SERVICE UPDATE

SUBJECT: STARTER MOTOR B+ CABLE ATTACHMENT

MODELS: 2011-2013 CHEVROLET CAPTIVA

Page 7 May 2014 Bulletin No.: 14003

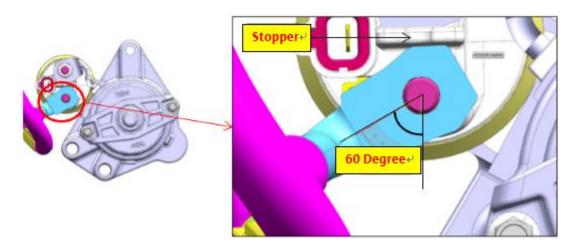
6. Remove the B+ cable nut and clean up the B+ stud if there is any contamination such as dust or oil.

7. Install new B+ cable nut and mark 'I' on the nut.
. **Tighten** the nut to 10 N.m.

[" I " Marking]

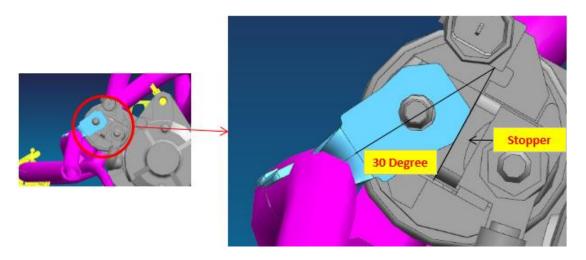
IMPORTANT: Keep the terminal stack condition properly and keep the angle as requested.

• A/T & M/T (Non-Stop& Start)

• M/T (Stop& Start)
